# Hawthorns Area of Windy Hill Preserve Public Access Working Group

## Meeting #6 – Site Meeting and Design Discussion March 2024

PAWG Meeting #6 Site Meeting and Design Discussion Materials

**Hawthorns Area Public Access Working Group**  
**Parking Options 8 and 9 Concept Design Comparison**  
*Hawthorns Area Plan*

# HAWTHORNS AREA - OPTION 8 & 9 COMPARISON

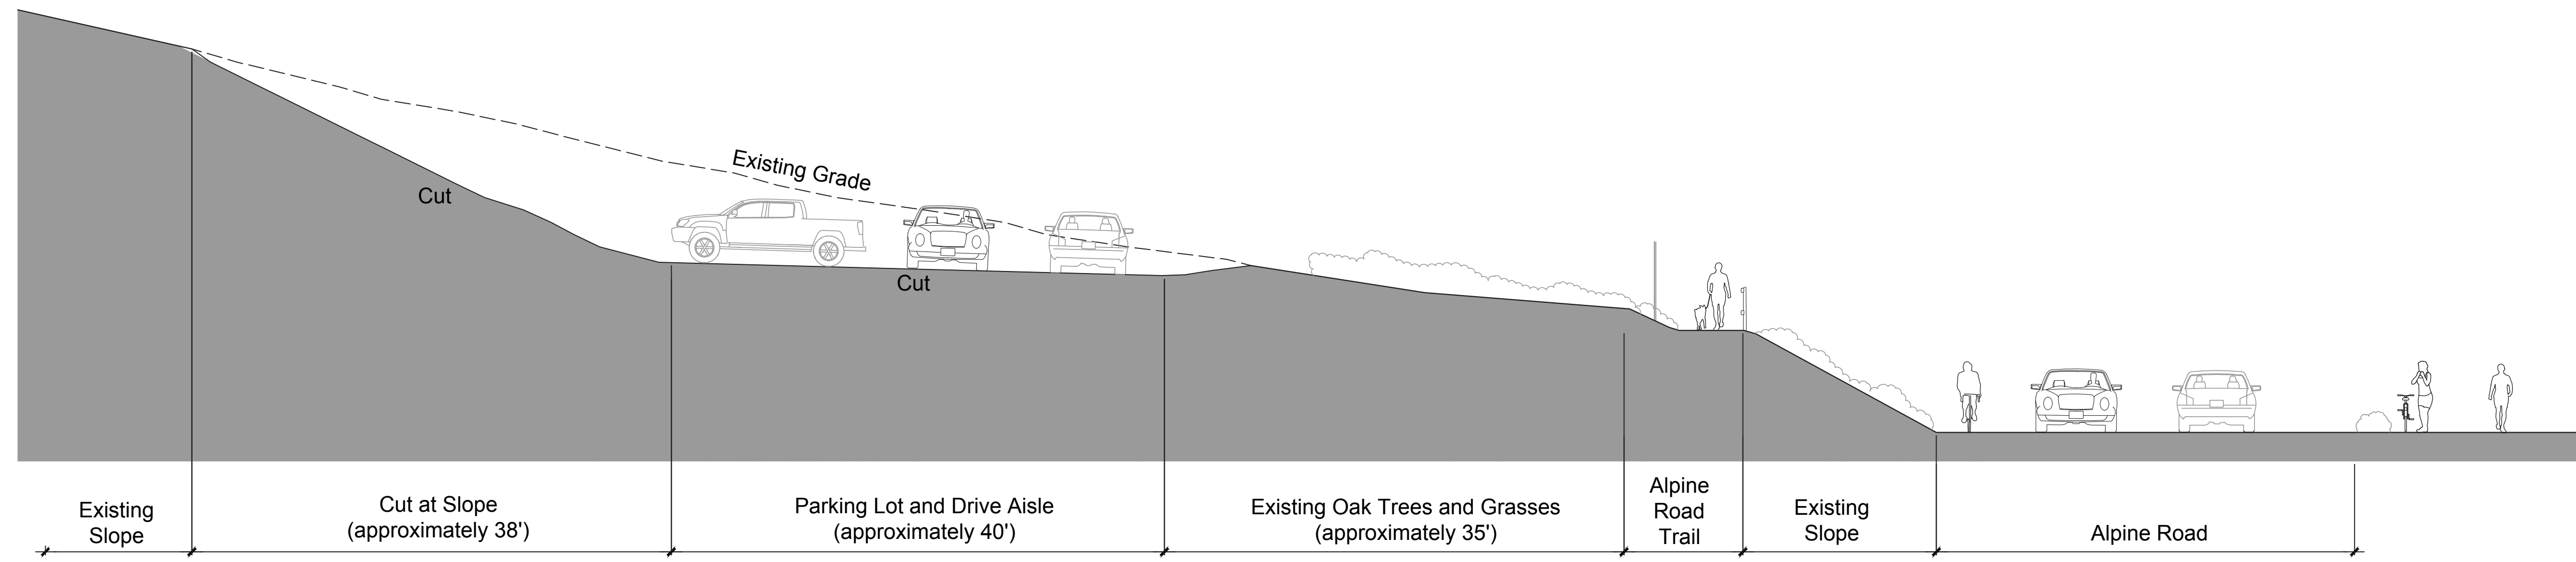
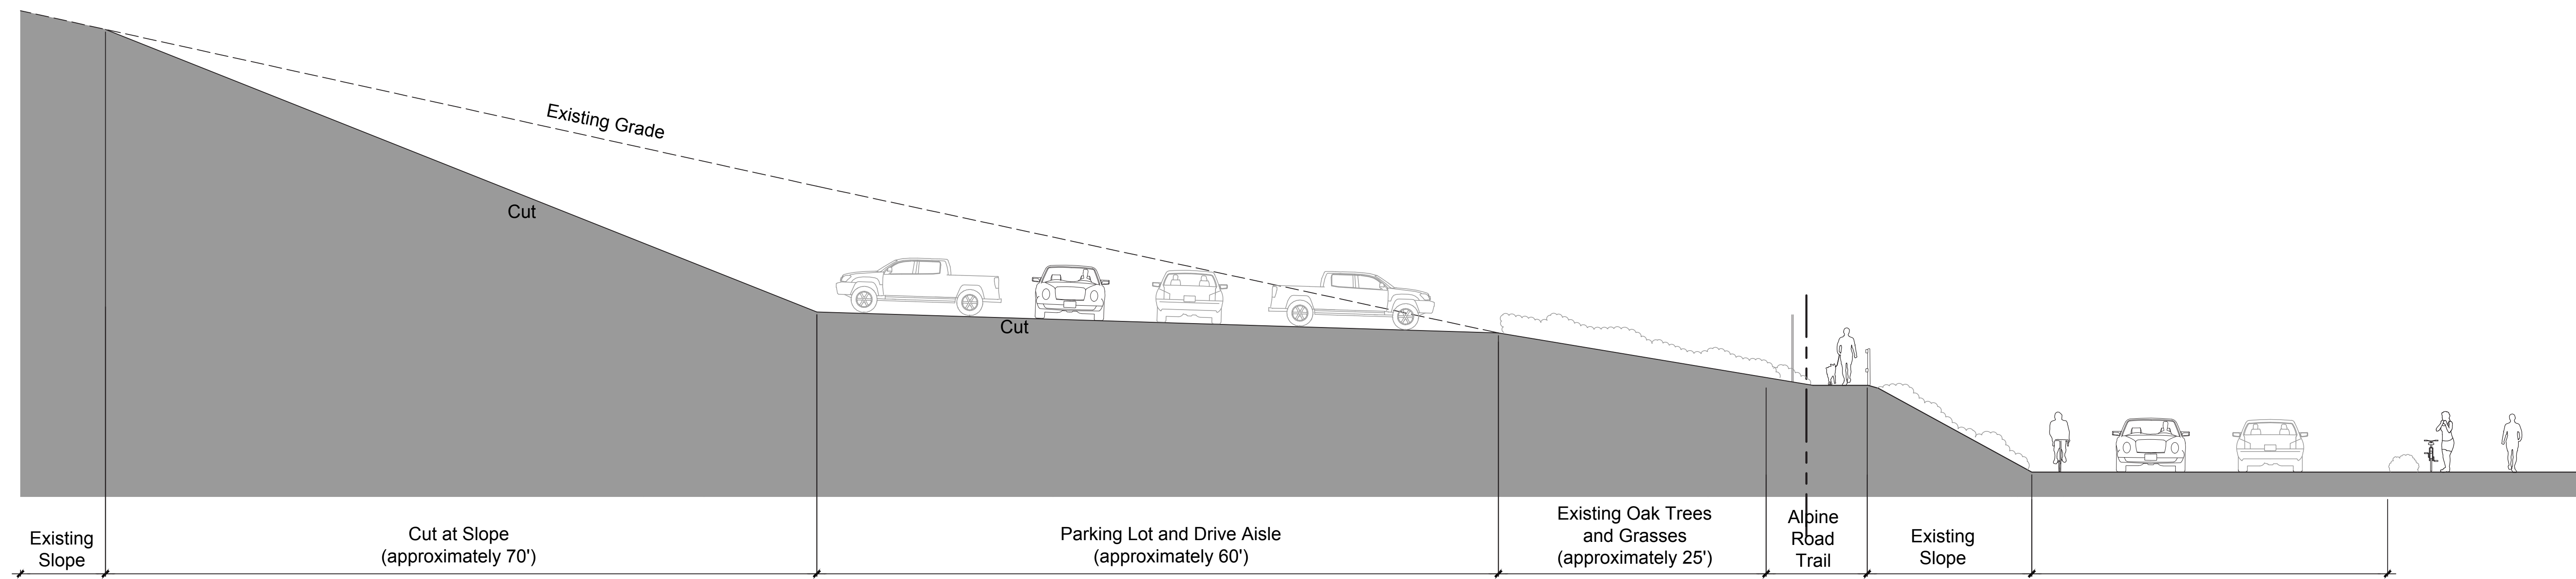
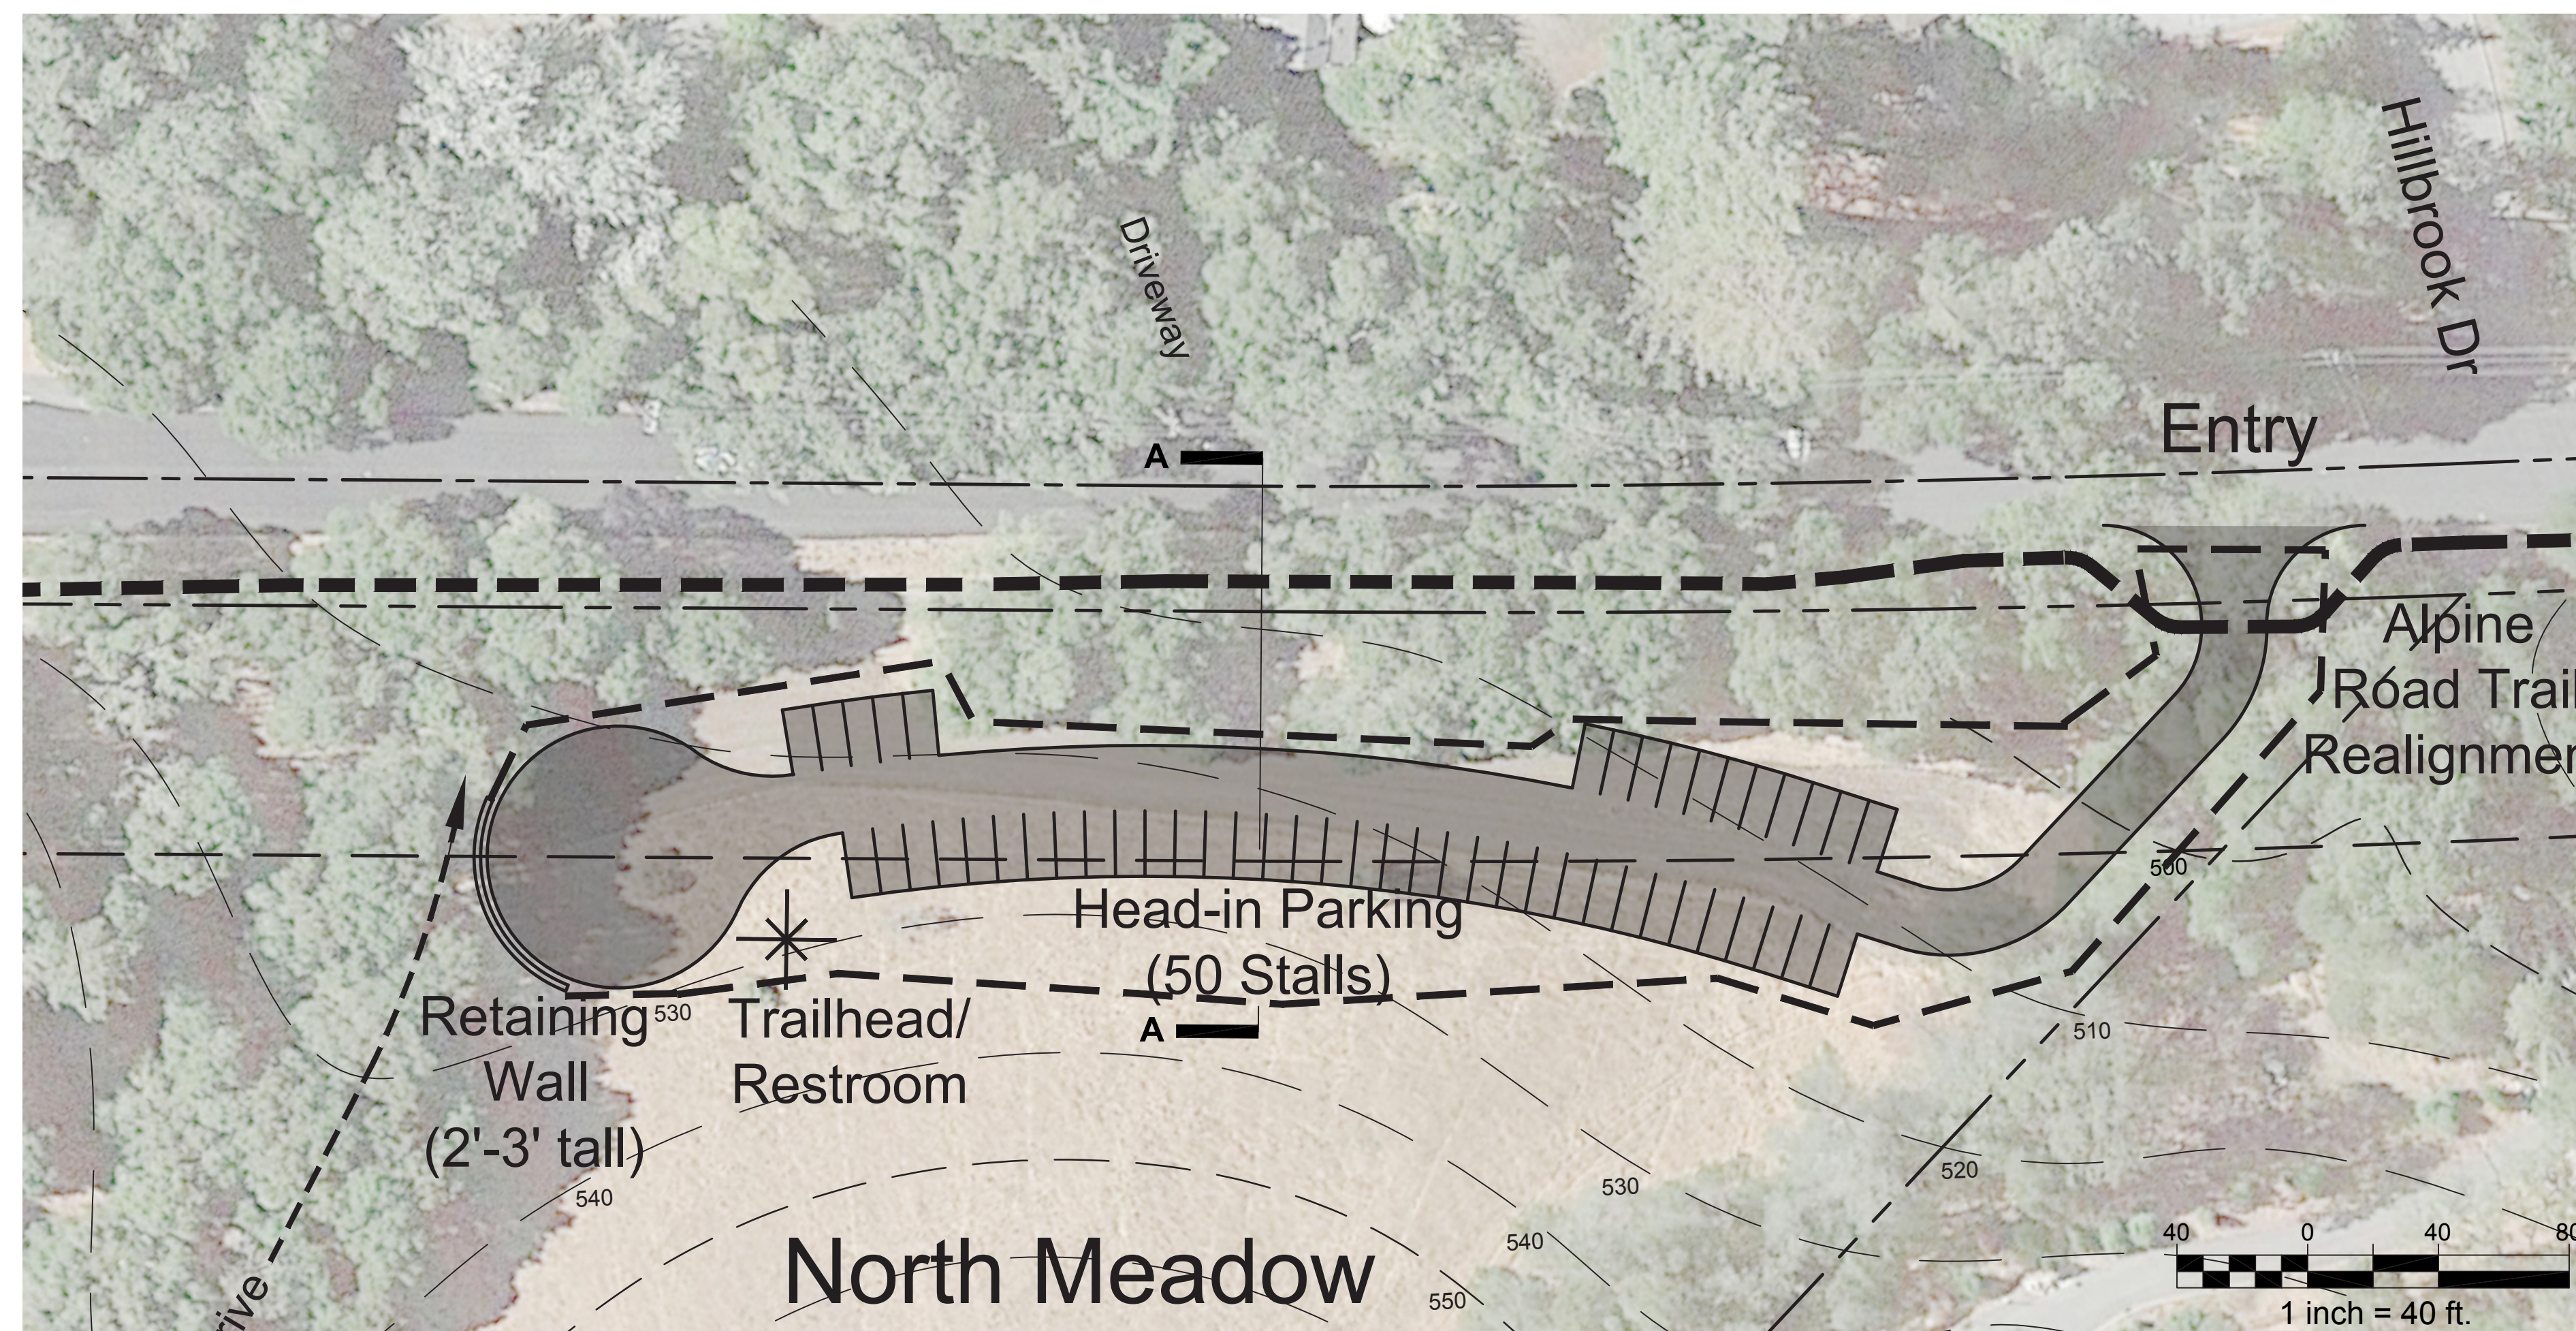
After the February 29, 2024 Public Access Working Group (PAWG) meeting, two PAWG members sent the Midpen project team a couple other parking lot options to explore. The project and consultant team looked into these ideas to assess the potential number of parking spaces the new location could accommodate and the impact on the existing site. The result is parking lot option 9, which locates a 30-space parking lot to the right of the existing driveway. During the upcoming site meeting on March 24, the project team will guide the PAWG to this location to gather their feedback on whether they would like to pursue this option further.

For the PAWG's consideration, attached is a side-by-side high level comparison of options 8 and 9. The excavation required for option 9, particularly into the hillside, will be considerably more extensive than for option 8. Both options assume a 2:1 slope for the uphill cut. While option 8's section appears similar, the cut/fill is closer to being balanced onsite due to fill at the entrance and turnaround areas. In option 9, however, all grading will involve cutting into the hillside, resulting in significant off-haul and a 12-foot-high retaining wall. The cut and fill could be balanced if two 6-foot-high walls are installed on the uphill and downhill side of the parking lot.
